RE: **Wilder Project, FERC No. 1892-026**
Bellows Falls Project, FERC No. 1855-045
Vernon Hydroelectric, Project No. 1904-073

Great River Hydro
ILP Study 2 and Study 3
Riverbank Transect and Riverbank Erosion

**Supplement to Final Study Report dated November 15, 2017*

CONTENTS: Landowner's comments re the above referenced documents submitted by Great River Hydro on November 15, 2017, and a letter from Mr. John Ragonese of Great River Hydro to FERC dated January 16, 2018.

Above: Left, April 1943 National Geographic. Right by Winston Pote about 1940.

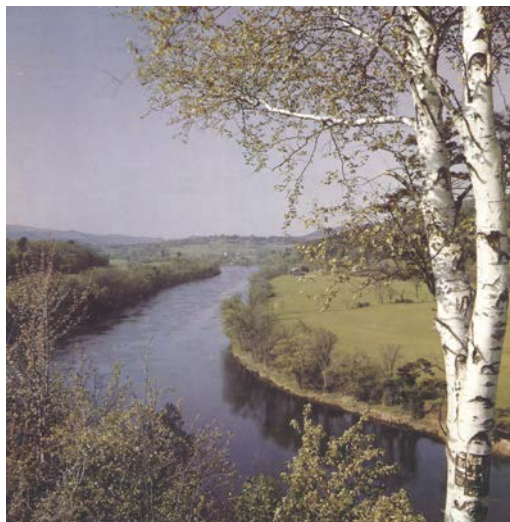
When one looks historically at “high flow events” on the Connecticut River, the greatest such event was probably the Hurricane of 1936 when both bridges in Lyme, New Hampshire, to East Thetford, Vermont, and to North Thetford, Vermont, were washed out. Pictures taken after that storm of the land located *between those two bridges* and now owned by my family show a strong riverbank with a strong riparian buffer— all of which survived the storm of June 1936. The man-made bridges failed, but the riverbank survived.

The soils found here in 1936 are the same soils that are found here today. In the Field Study of February 4, 2017, (page 124) the soil in this valley is described: “The character of sediments in the study area creates banks with limited resistance to erosion. The bank sediments at the monitoring sites, representative of the study area as a whole, are nearly ubiquitously comprised of fine-grained and unconsolidated floodplain or glaciogenic sediments that are particularly prone to erosion.” (Emphasis added.)

Therefore, GRH and its consultants want to argue that the soil in this valley is “prone to erosion” but the erosion that we see here is caused by unspecified “high flow events,” yet when we look at the highest flow event of the past century, there was no visible erosion as a result of that storm. Does it make sense that the erosion that we see today is the result of mysterious and unidentified high water events? No, this does not make sense.

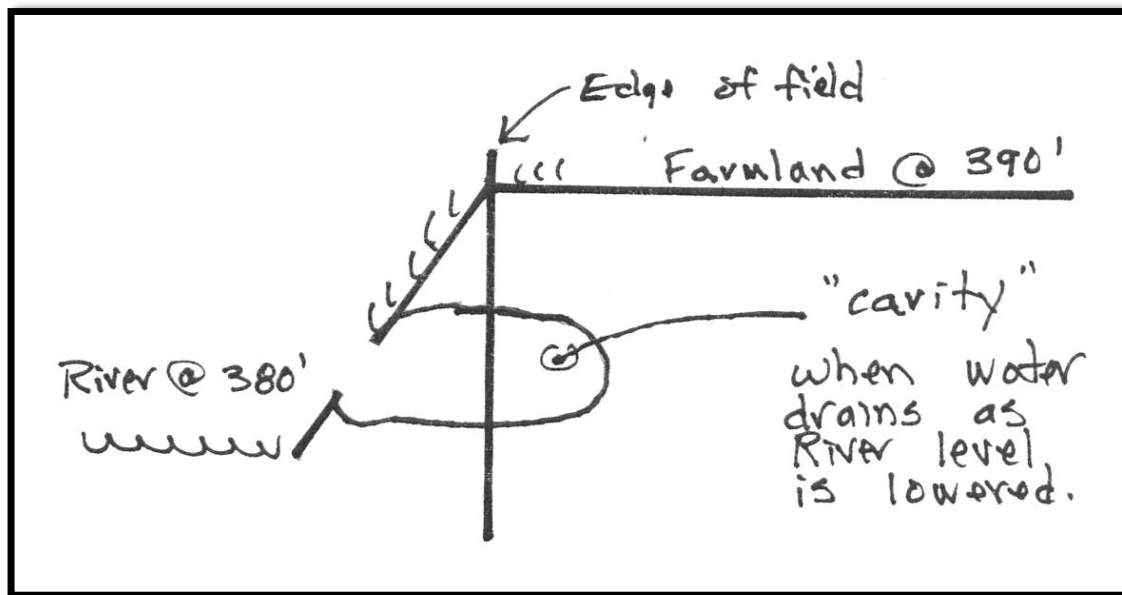
You only have to make observations as you walk along the riverbank to realize that there is a tremendous amount of erosion here. I first illustrated my observations in the Study Request that I submitted five years ago, on February 25, 2013. On page 14 of that document I included the below diagram:

In this diagram, the water level has been raised to 385’ and the river water has saturated the soil, now described by GRH as “*fine-grained*” and “*particularly prone to erosion.*”

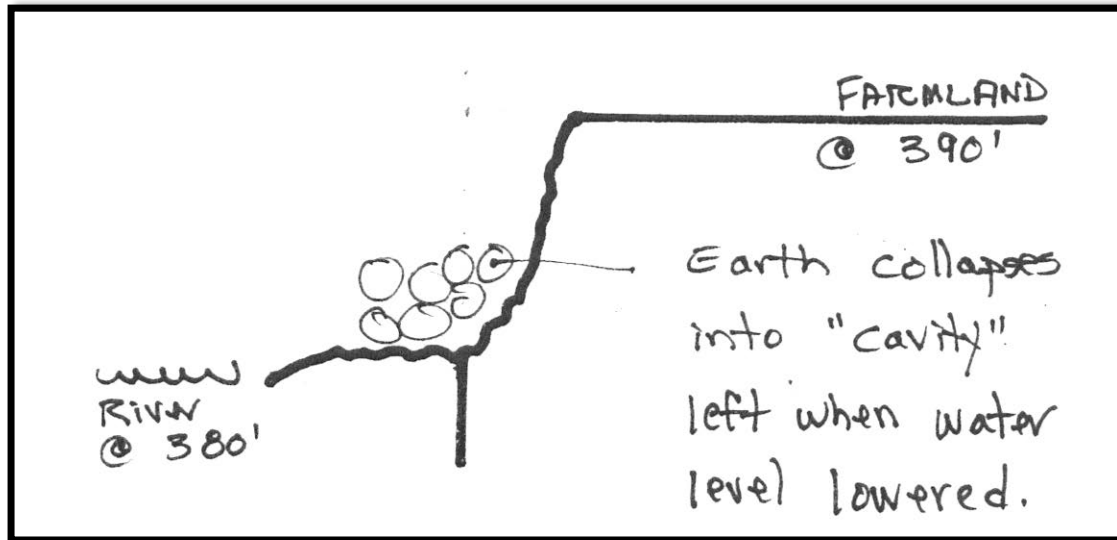
The water level is lowered and, as Mr. Cook has written, "soil is sucked out of the river bank." I illustrated this in my 2013 study request, reprinted below:

How do we know this happens? Below is a picture of at least a four-foot hole in the riverbank that has been caused by "sucking" the soil out of the riverbank when the water was lowered as the result of "project operations." It happens.

This is the very situation that Dr. McIntyre described and asked about on March 8, 2018, but his question and comments were dismissed by Mr. Ragonese.
